STAFF REPORT

SUBJECT: H-2022-0076
KeyBank Meridian Branch – CUP

LOCATION: 3485 W. Chinden Blvd., in the NW 1/4 of Section 27, T.4N., R.1W.

Conditional Use Permit for a drive-through establishment for a financial institution within 300-feet of another drive-through establishment, an existing residence and residential zoning district, on 1.04-acres of land in the C-G zoning district.

B. Proposed Landscape Plan (dated: 9/20/22)

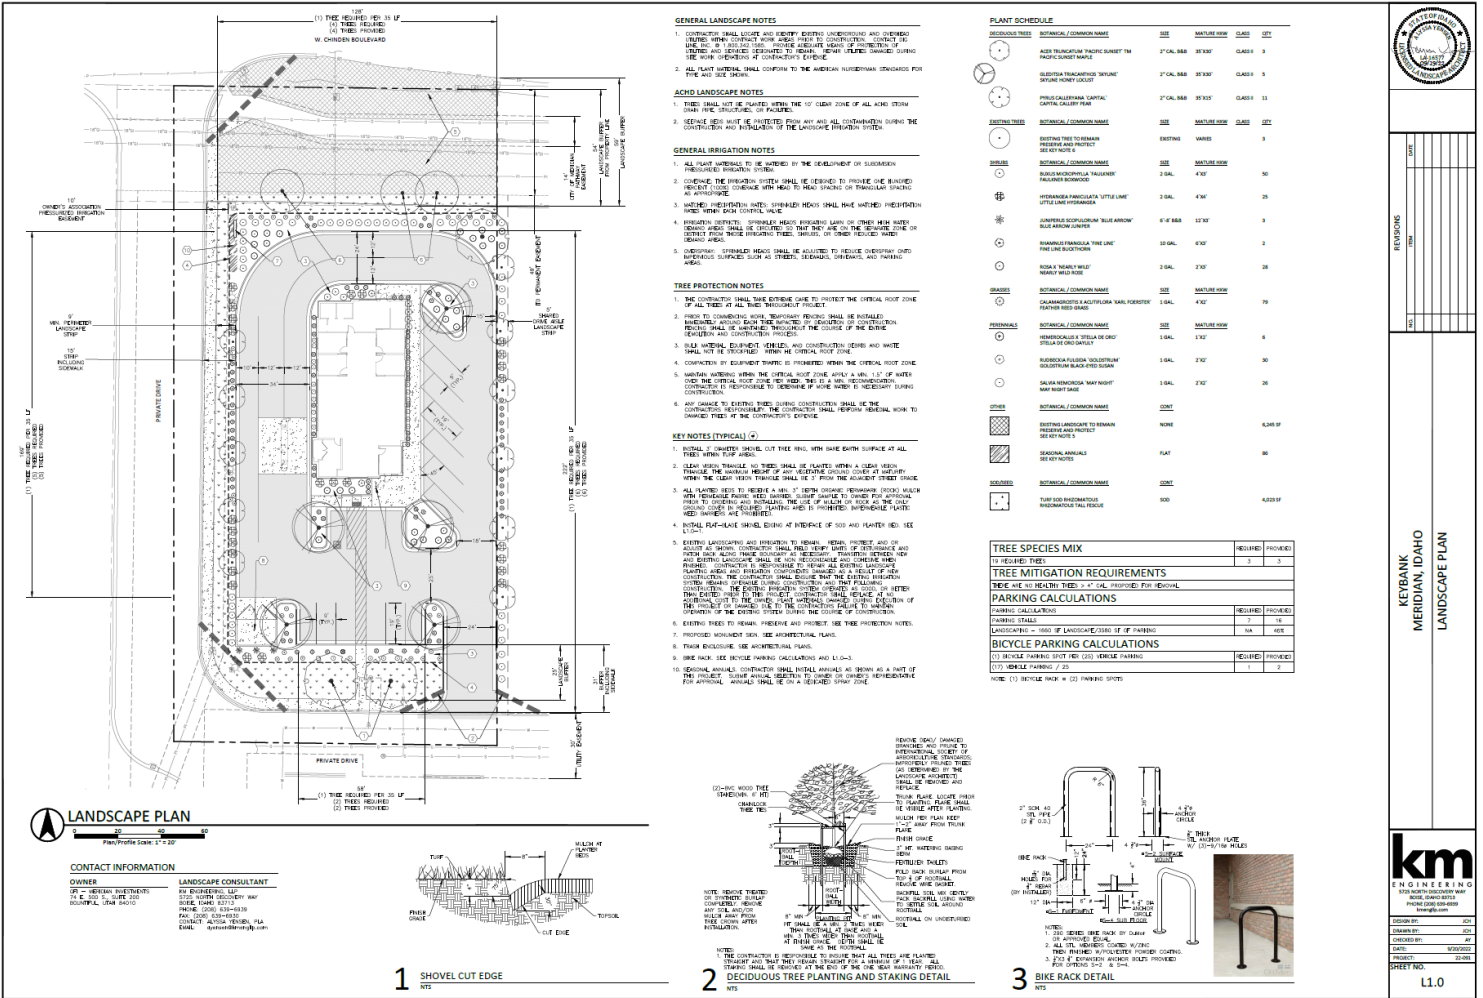
- C. Landscape shrubbery shall be limited to no more than three (3) feet in height between entrances and financial transaction areas and the public street. *The reed grass depicted on the landscape plan in the buffer along the west boundary of the site and the falkner boxwood in the buffer along the northern boundary of the site on the west side of the building has a mature height of 4-feet, which is not allowed; the landscape plan should be revised to comply with this standard.*

Parking lot landscaping is required to be provided in accord with the standards listed in UDC [11-3B-8C](#). **A minimum 5-foot wide perimeter buffer is required along the east boundary of the site per UDC 11-3B-8C.1, landscaped per the standards listed in UDC [11-3B-8C.1b](#).** The buffer on the adjacent property to the east does not meet this requirement; remove from the plan.

The sidewalk on the south and east sides of the building where parking abuts should be widened to 7-feet to allow vehicles to overhang 2-feet (the length of stalls may be reduced to 17-feet); or, wheel stops should be provided within parking spaces to prevent vehicle overhang in accord with UDC 11-3C-5B.3, 4.

- d. Depict shrubbery that is no more than three (3) feet in height at maturity between entrances and financial transaction areas and the public street as set forth in UDC [11-3A-16C](#). *The reed grass within the planter along the west boundary of the site and the falkner boxwood in the buffer along the north boundary of the site exceed 3-feet in height at maturity and should be replaced with shrubbery that meets this standard.*

- f. Widen the sidewalk to 7-feet on the south and east sides of the building where parking abuts to allow vehicles to overhang 2-feet (the length of stalls may be reduced to 17-feet); or, provide wheel stops within parking spaces to prevent vehicle overhang in accord with UDC [11-3C-5B.3, 4](#).

- g. Depict a minimum 5-foot wide perimeter buffer along the east boundary of the site per UDC [11-3B-8C.1](#), landscaped per the standards listed in UDC [11-3B-8C.1b](#); remove the buffer on the adjacent property from the plan.
